PLANNING COMMISSION AGENDA

Title: Public Hearing - Conceptual Site Plan (amended), 335 South Frontage Road, Miles Bell LC, Applicant David Bell - ADMINISTRATIVE DECISION

UT183-CF | 04:32 PM THURSDAY 22 JUNE 2023 | P:\2023-0103 AIDEN BELL-DAVES COMPLETE AUTO IMPROV.DRAWINGS\SHEETS\CS101.DWG

Title: Public Hearing - Conceptual Site Plan (amended), 285 South Frontage Road, Aiden Bell LC, Applicant David Bell - ADMINISTRATIVE DECISION

SITE PLAN

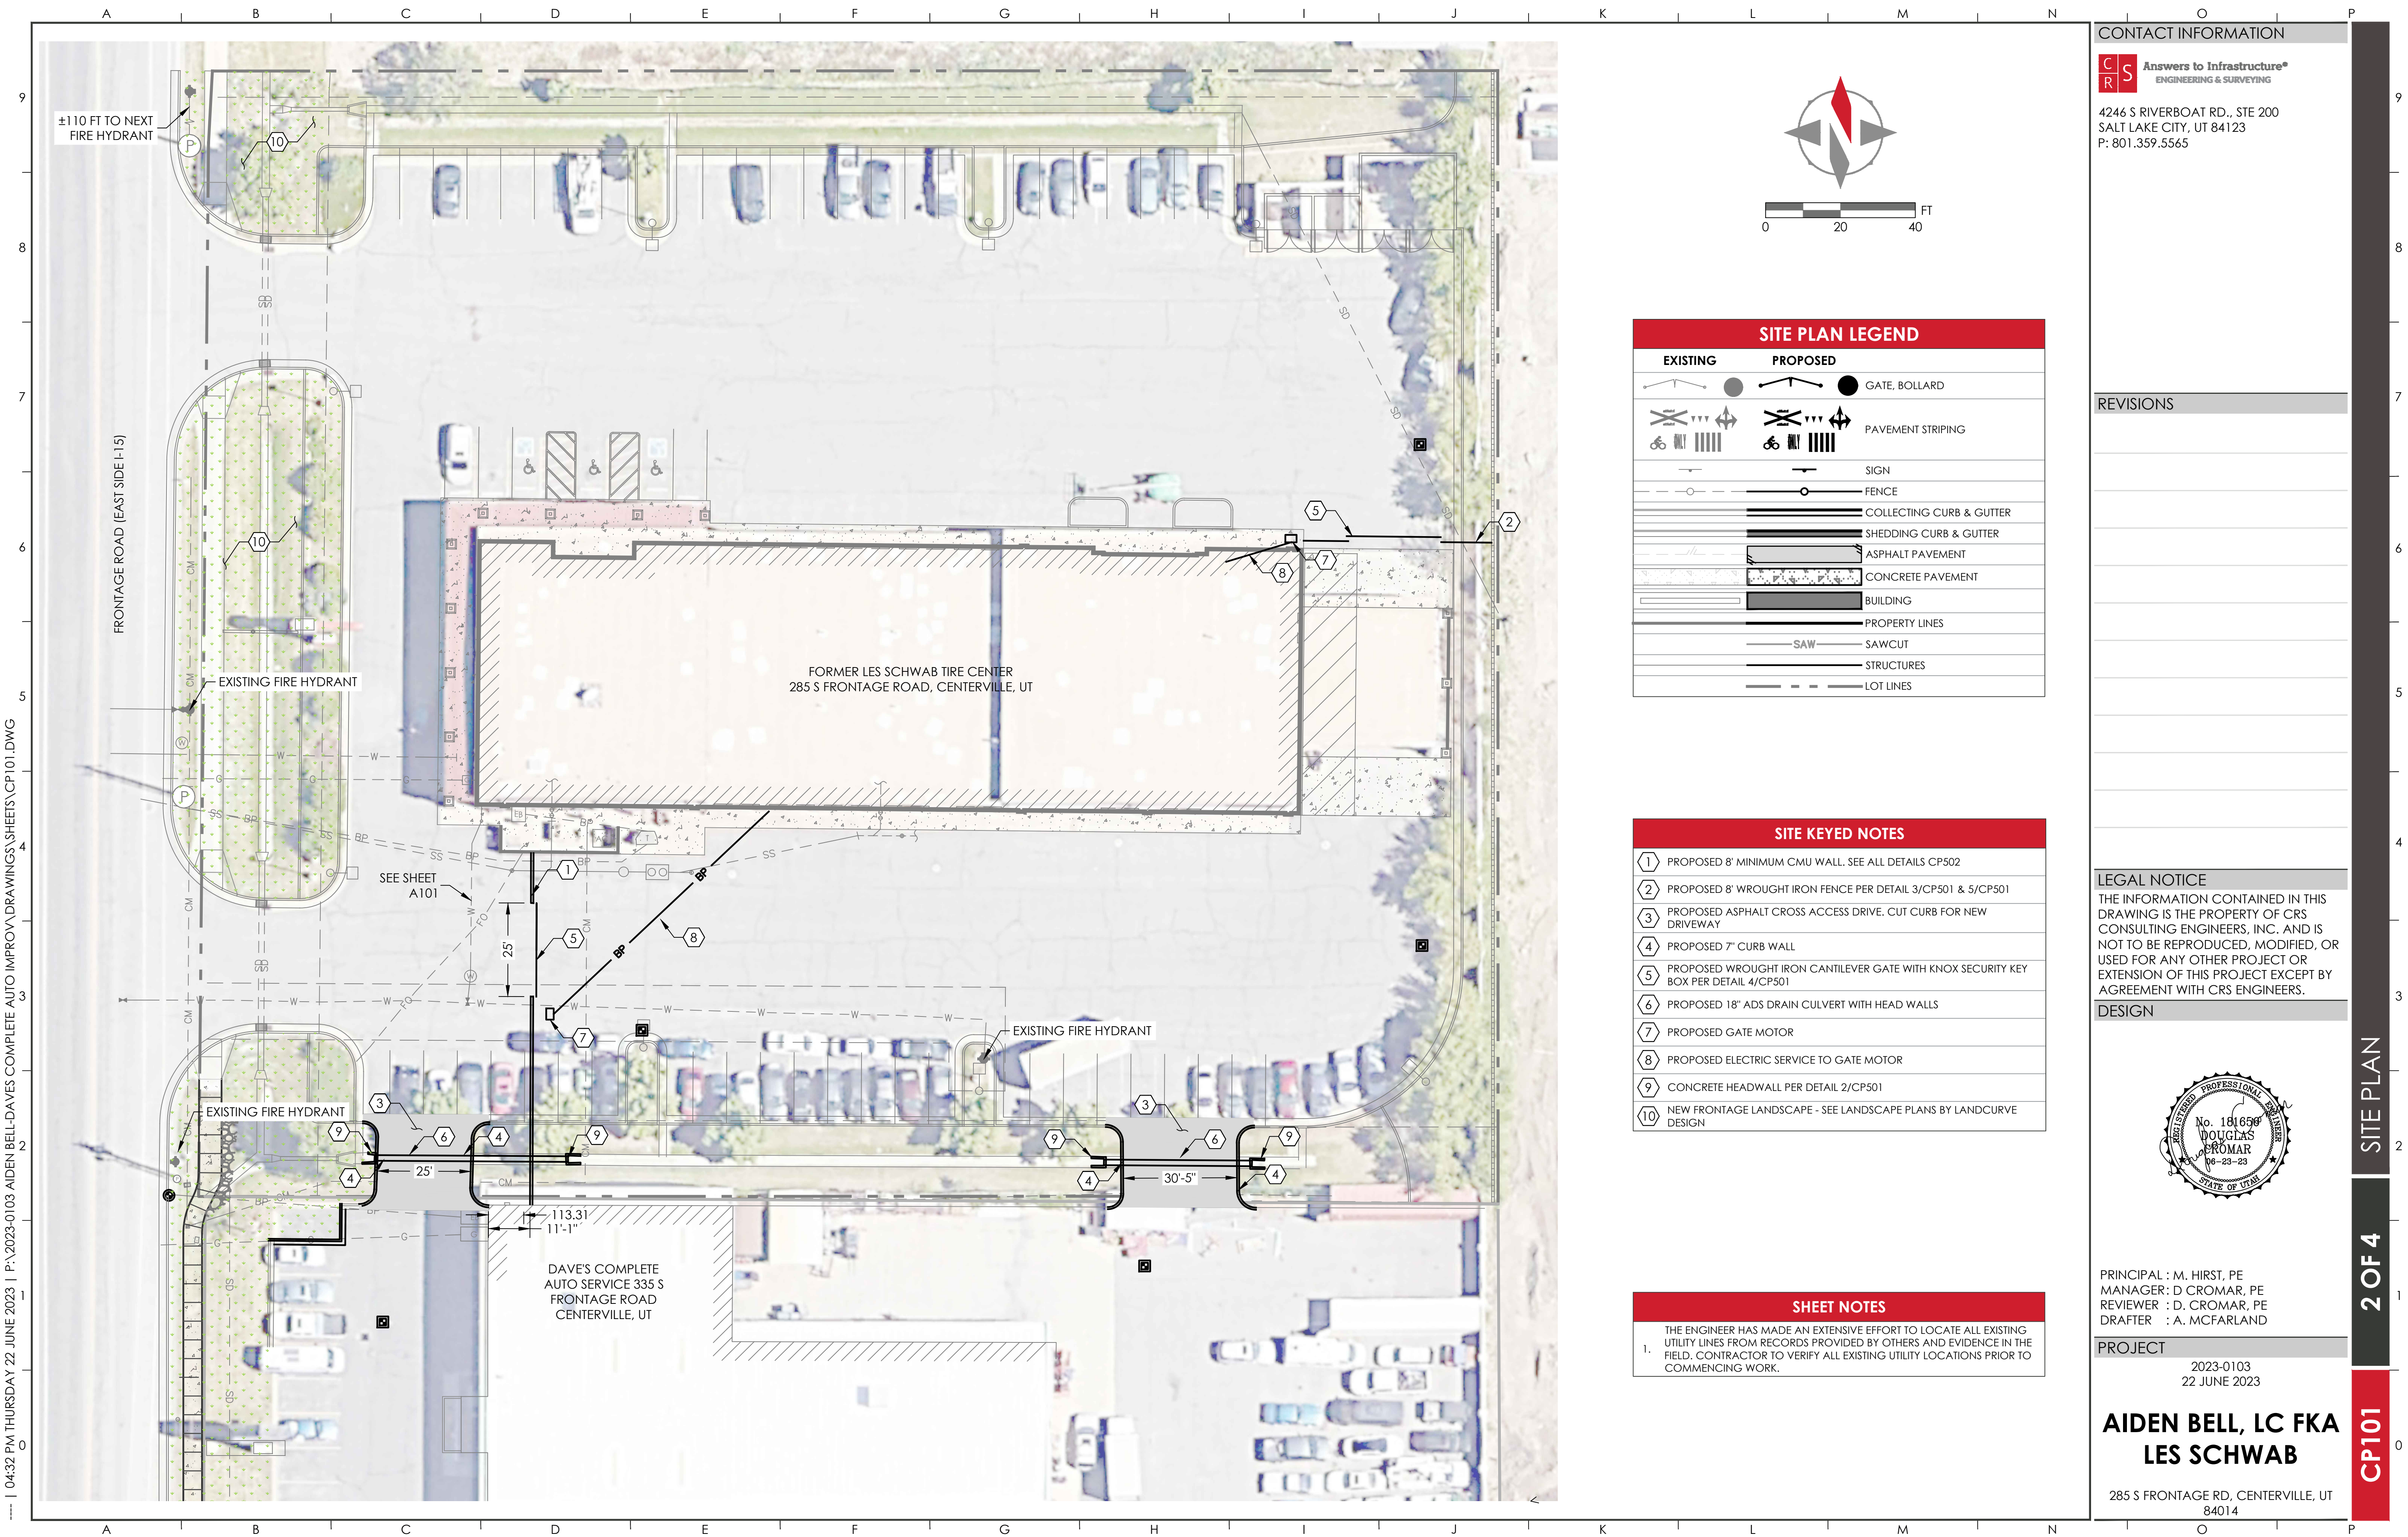
Original Area of Nonconformity Extent Claimed	Amended Area of Nonconformity Extent	Compliance
Vehicle and Equipment Repair	19 stalls indicated (minus one stall – see landscaping plan)	Needs to add back one (1) stall on-site (current code is 55 stalls)	Undetermined – likely feasible

Fences & Walls – From review of the Conceptual Site Plan, new 8’ tall CMU fence/screen wall is being proposed that connects the existing buildings (*Dave’s Complete Auto and former Les Schwab site*). Although, the fence/wall is substantially located on the former Les Schwab Site, a small portion of the fence/wall is located on the subject site for this application.

According to CZC 12.55.110(a)(3), the Planning Commission may approve the proposed 8’ fence (in this case -with the side yard area adjacent to the building) with the findings by the Planning Commission that is to be a benefit to the surrounding properties and/or help to buffer the use and is in the City’s best interest. The application indicates that the secure yard area is for impounded vehicles, needed for security purposes and is more aesthetic than using a fence system with “razor wire.”

3. The final site plan submittal shall also address the following:
 - a. Provide one (1) additional parking stall to replace the stall that is being eliminated in order to maintain original nonconforming parking stall count.

- b. Submit final construction plans for the public improvements and related modified storm water management system plan to be deemed acceptable by the City Engineer

1 8' CMU WALL
NOT TO SCALE

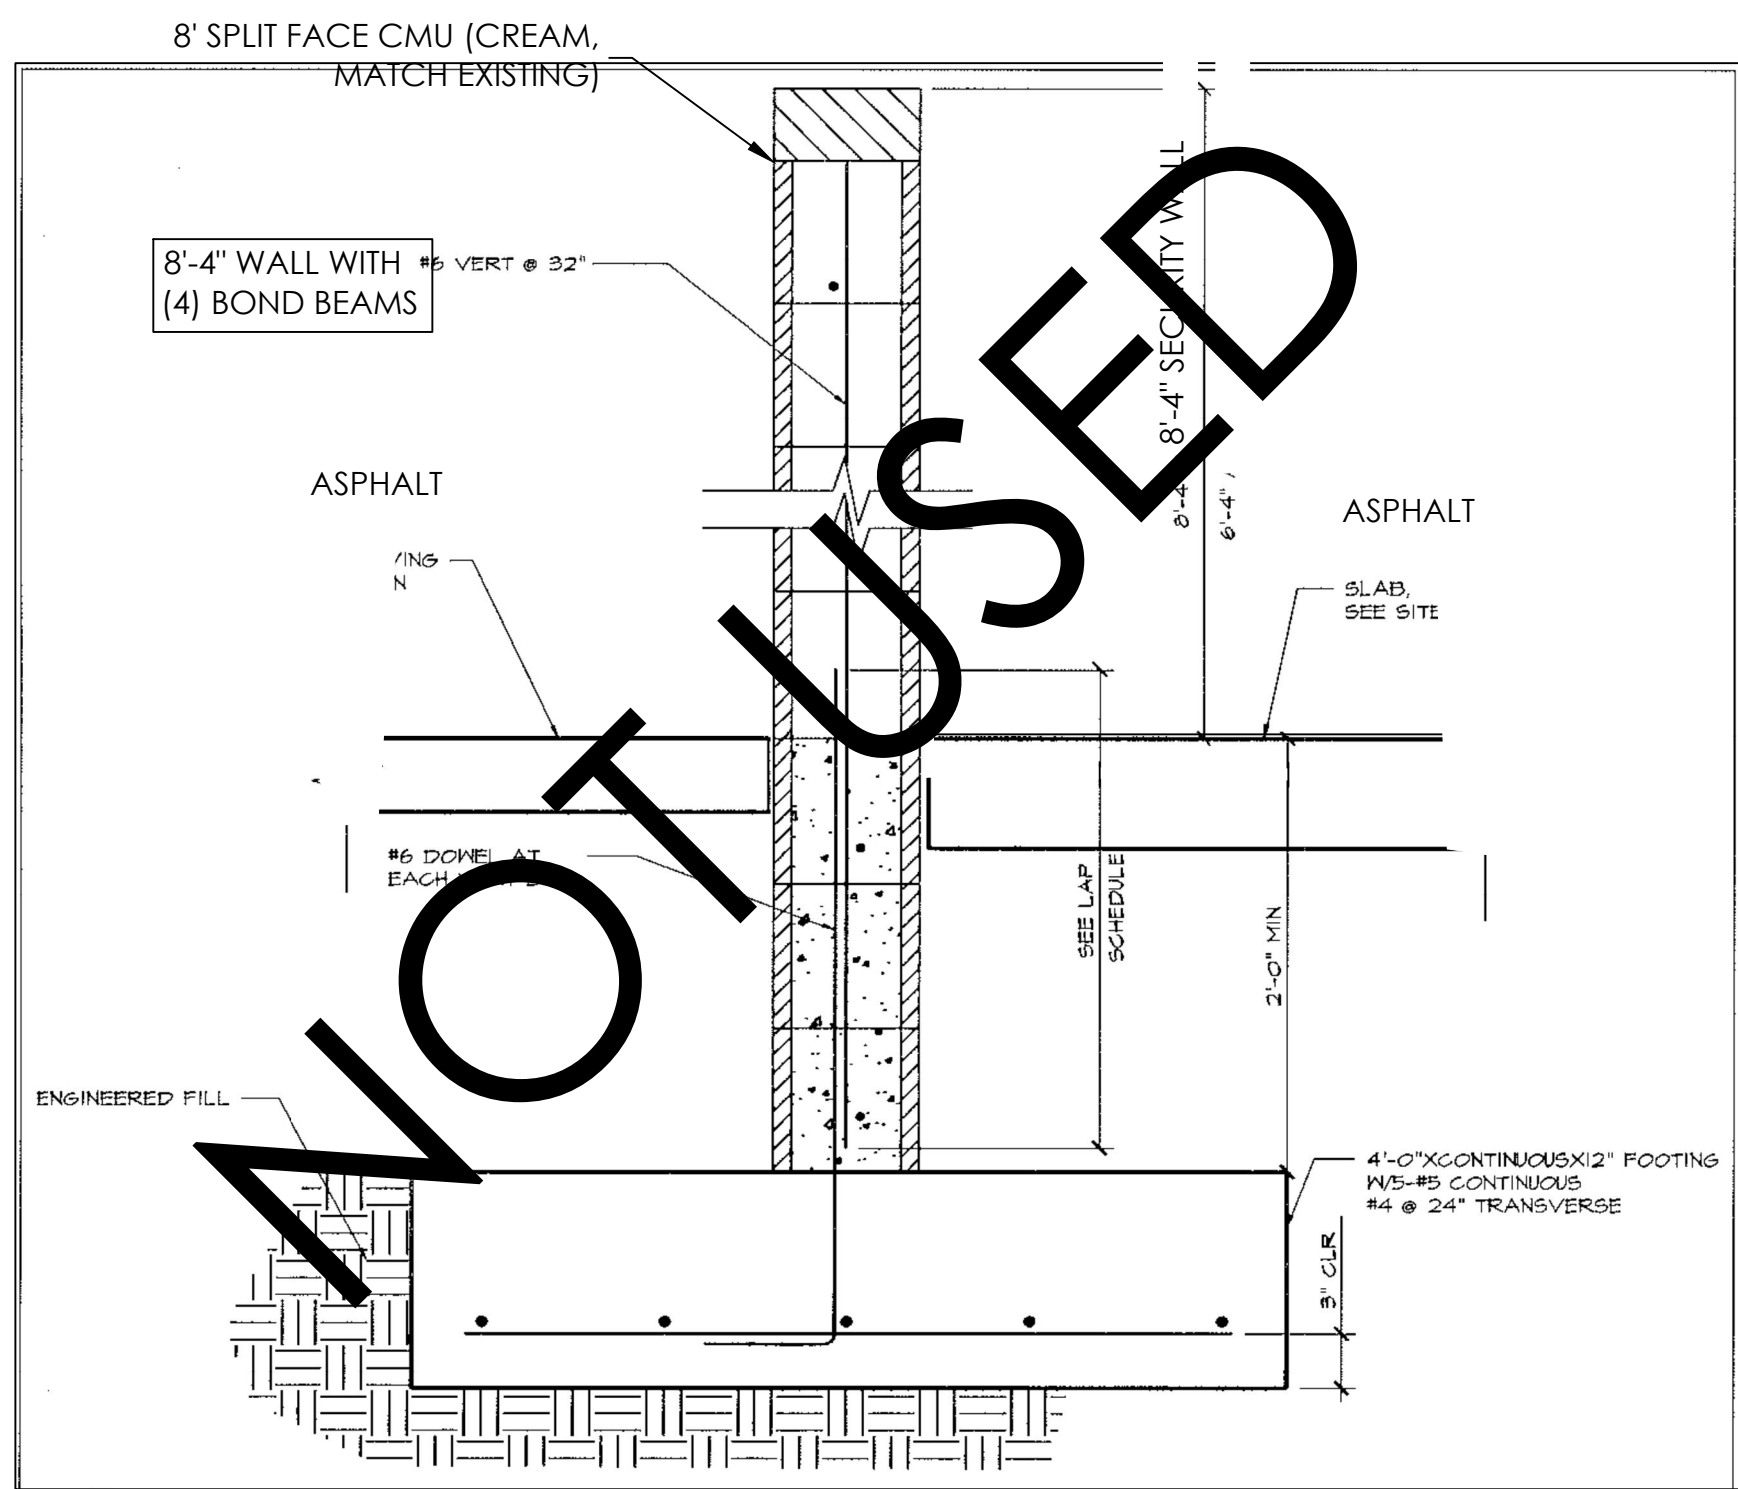
- **Fences and Walls** – The Zoning Code limits fence and wall heights to 6 feet or less as a permitted allowance for the site. However, at the discretion of the Planning Commission, the site may be approved with a wall or fence up to 10 feet, if it is determined by them to be a benefit to the surrounding properties and/or help to buffer the use and is in the City's best interest. Please provide a narrative or illustrative argument for the reasoning to install a taller fence and submit this with your site plan application. (**Fence/Walls Depicted, Narrative/Illustrative Argument not Provided**)
-

- d) The Planning Commission finds that the proposed fence is for security purposes and its design is aesthetically compatible with the existing buildings that are being connected to create the desired security area.*

SITE PLAN

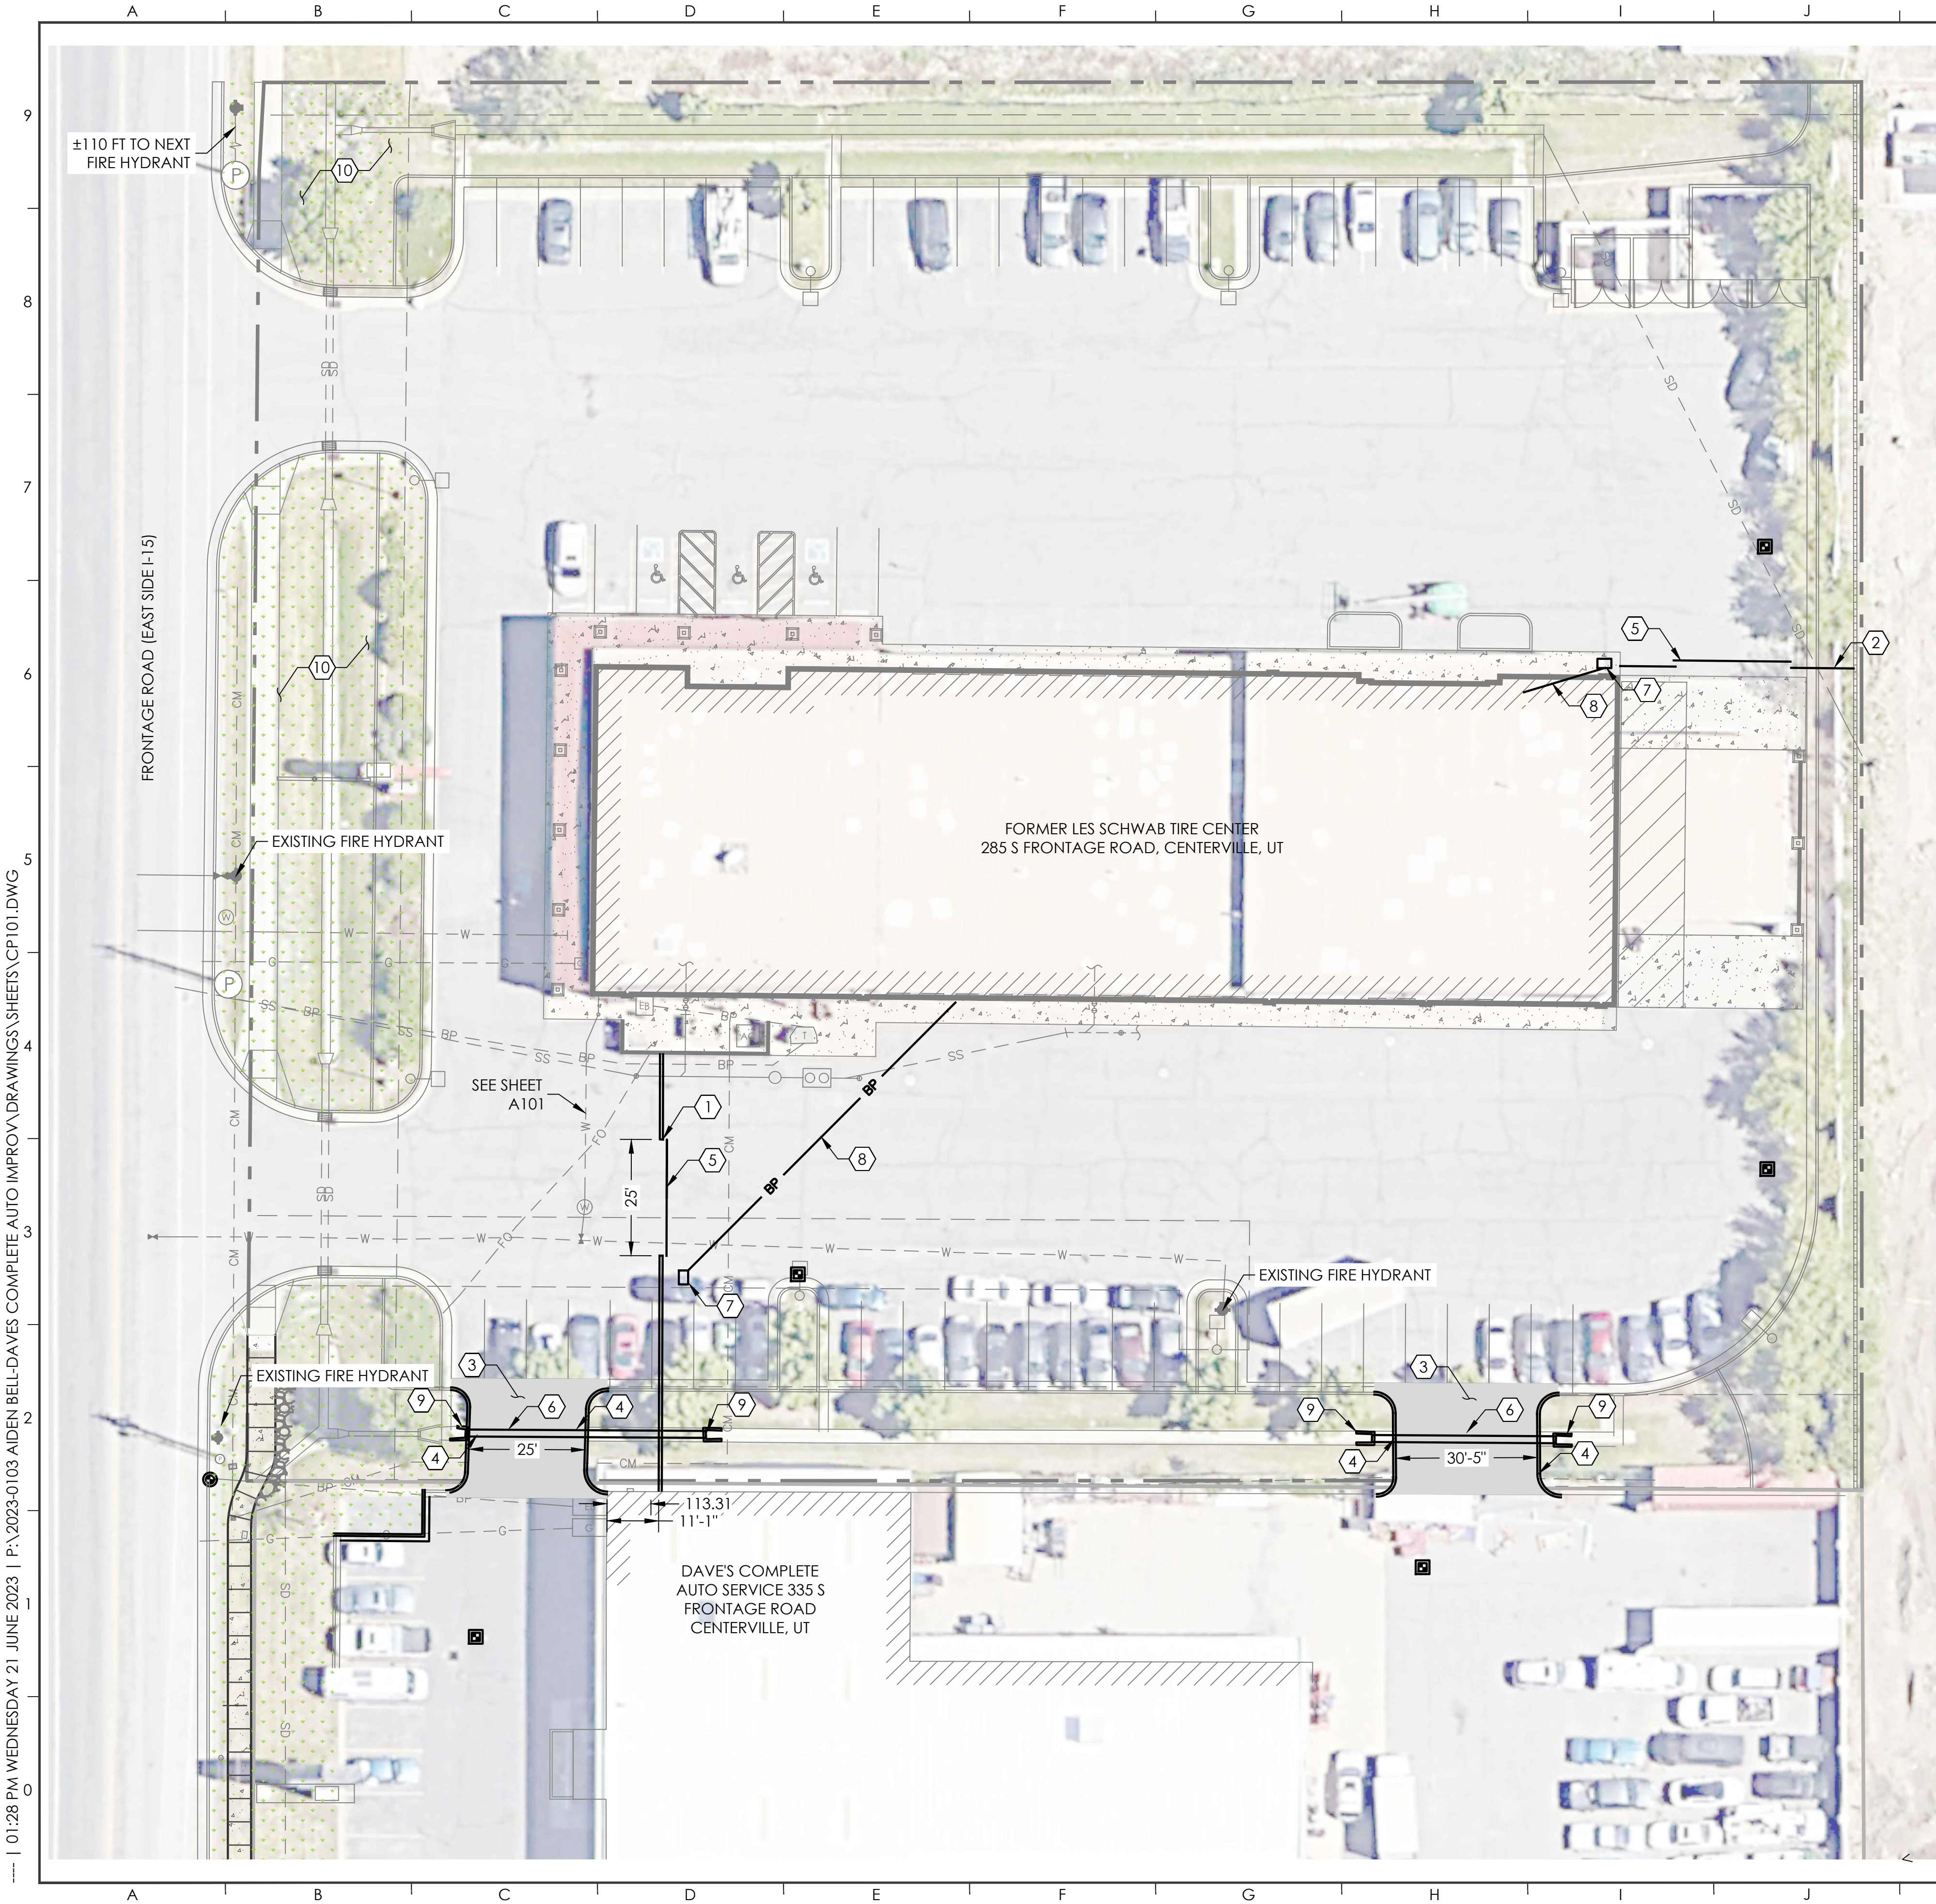
Original Area of Nonconformity Extent Claimed	Amended Area of Nonconformity Extent	Compliance
Vehicle and Equipment Repair	44 stalls indicated/55 aerial photo staff count (minus 4 stalls – see landscaping plan)	Needs to add back four (4) stalls on-site (current code is 83 stalls)	Undetermined – likely feasible

Fences & Walls – From review of the Conceptual Site Plan, new 8’ tall CMU fence/screen wall is being proposed that connects the existing buildings (*Dave’s Complete Auto and former Les Schwab site*). Although the fence/wall is substantially located on the former Les Schwab Site, a small portion of the fence/wall will also be located on the adjacent site – *see separate the replated application submittal*.

According to CZC 12.55.110(a)(3), the Planning Commission may approve the proposed 8’ fence (in this case -with the side yard area adjacent to the building) with the findings by the Planning Commission that is to be a benefit to the surrounding properties and/or help to buffer the use and is in the City’s best interest. The application indicates that the secure yard area is for impounded vehicles, needed for security purposes and is more aesthetic than using a fence system with “razor wire.”

- a. Provide four (4) additional parking stalls to replace the four (4) stalls that are being eliminated in order to maintain original nonconforming parking stall count.

- b. Submit final construction plans for the related modified storm water management system plan to be deemed acceptable by the City Engineer.
 - c. Prepare and submit the draft cross-access agreement for the proposed access drives and security fencing between this property and the site adjacent to the north (i.e. former Les Schwab site).
